1963 AB763 VIBROVERB "BLACKFACE" AMP

AB763 Add Presence Control

By RobRobinette.com

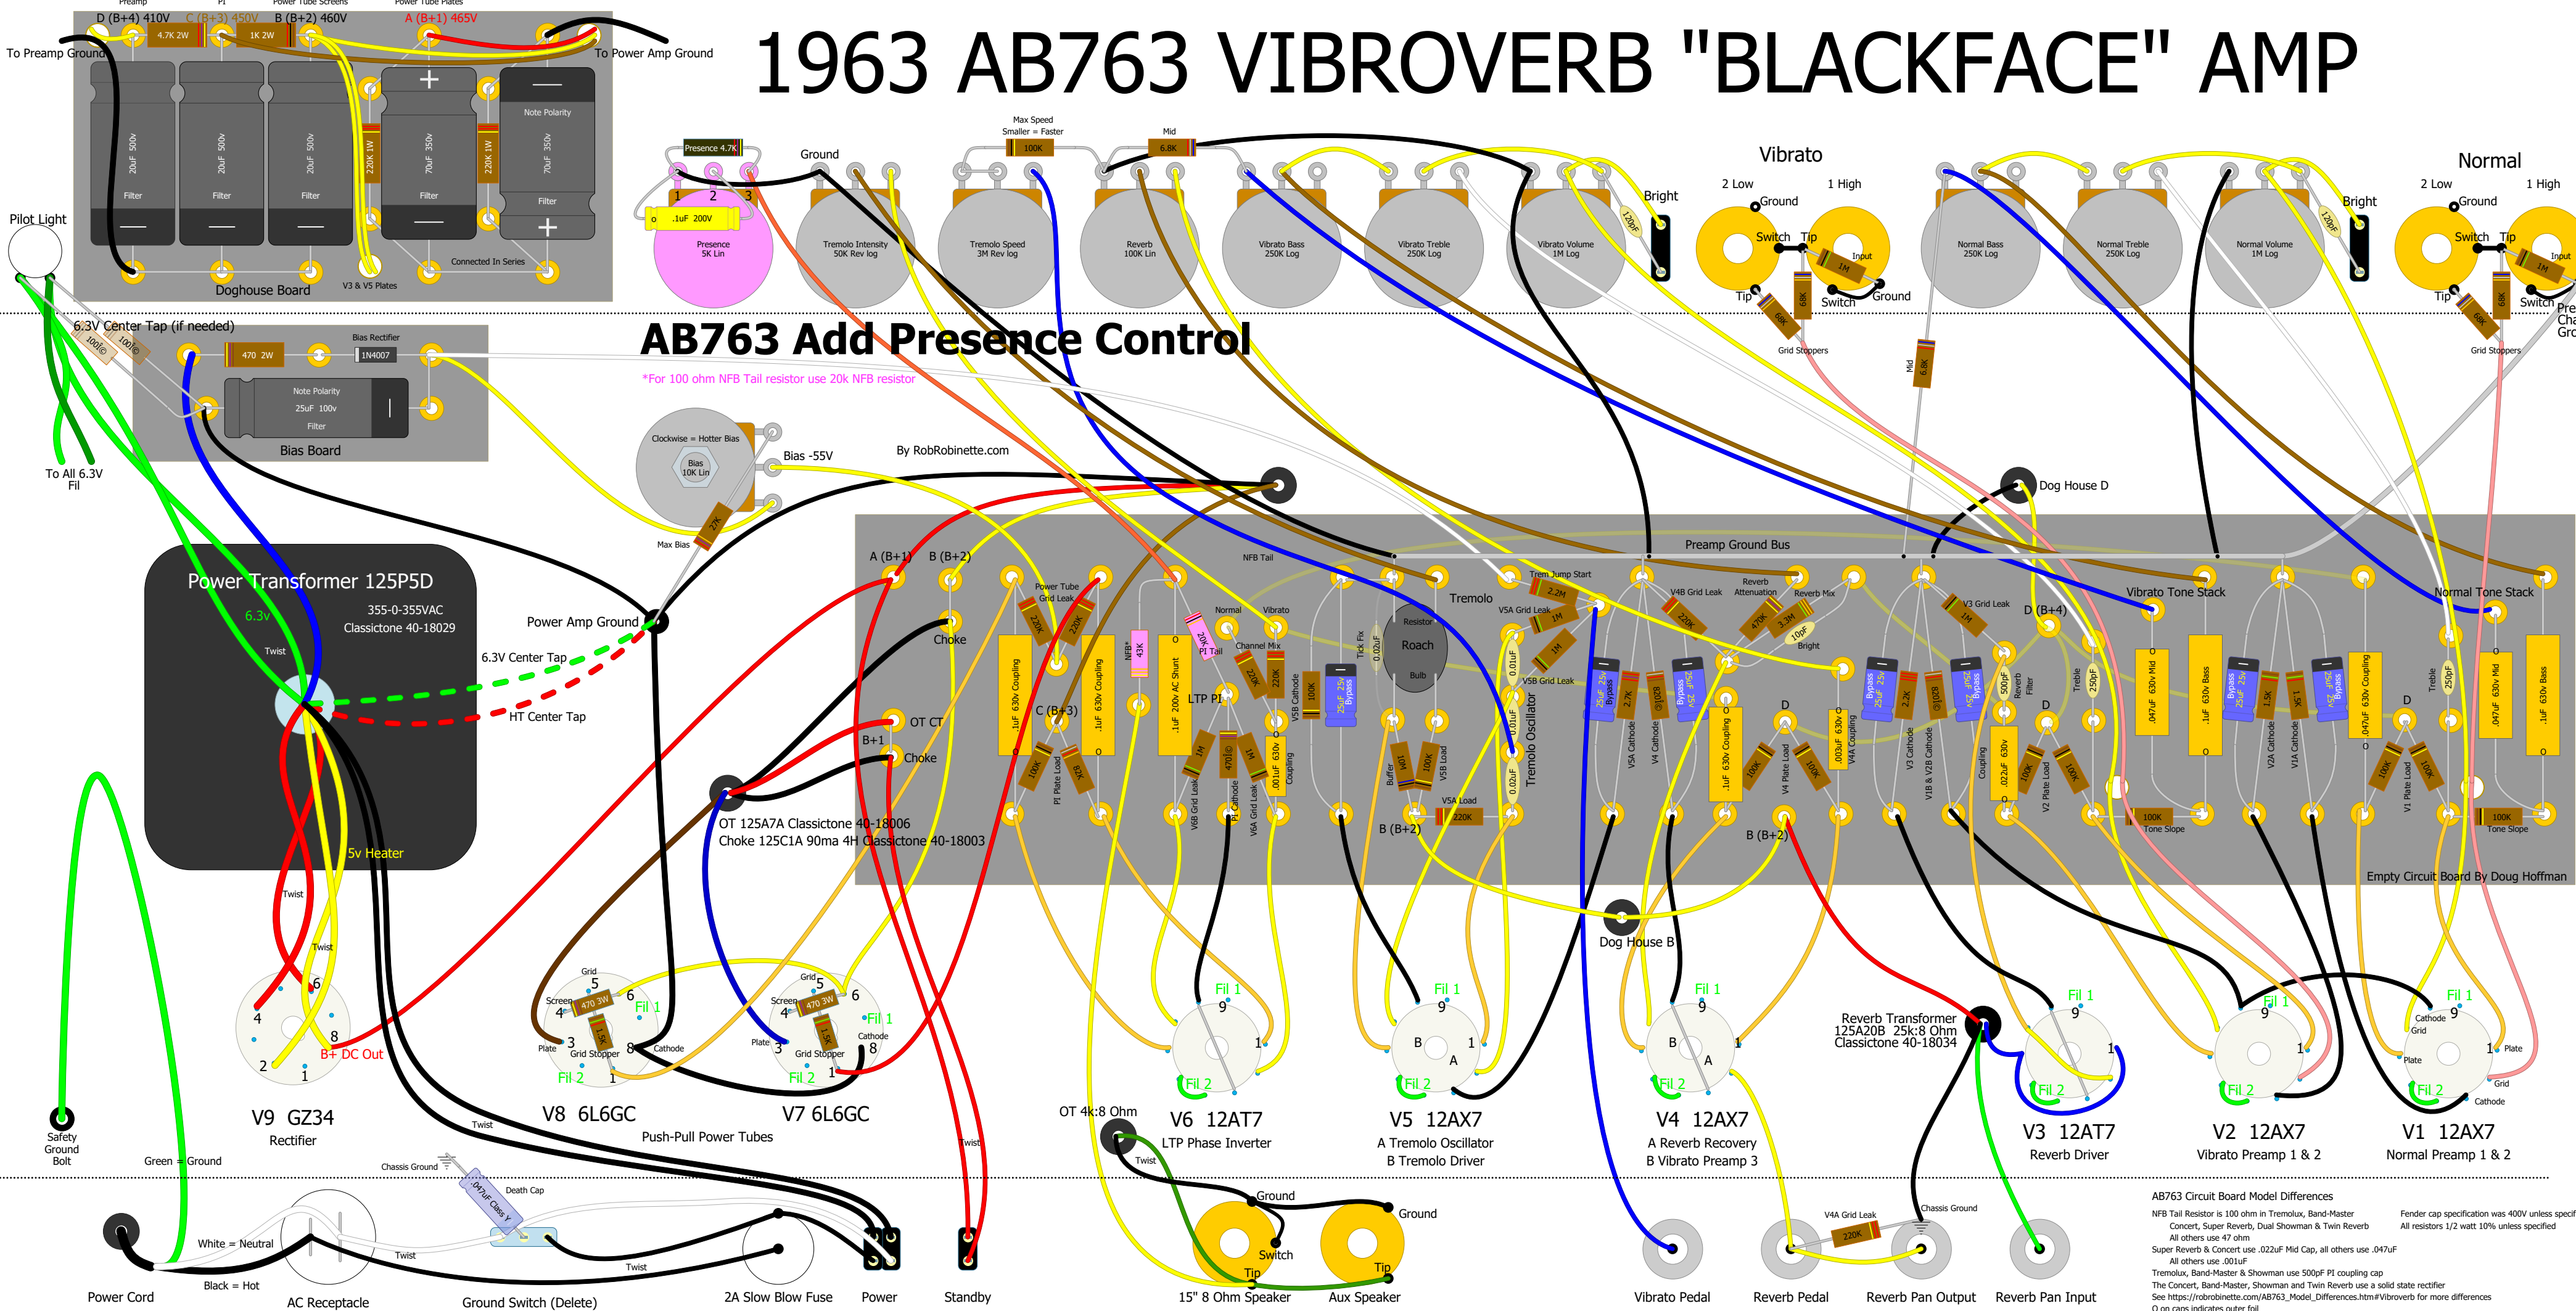
*For 100 ohm NFB Tail resistor use 20k NFB resistor
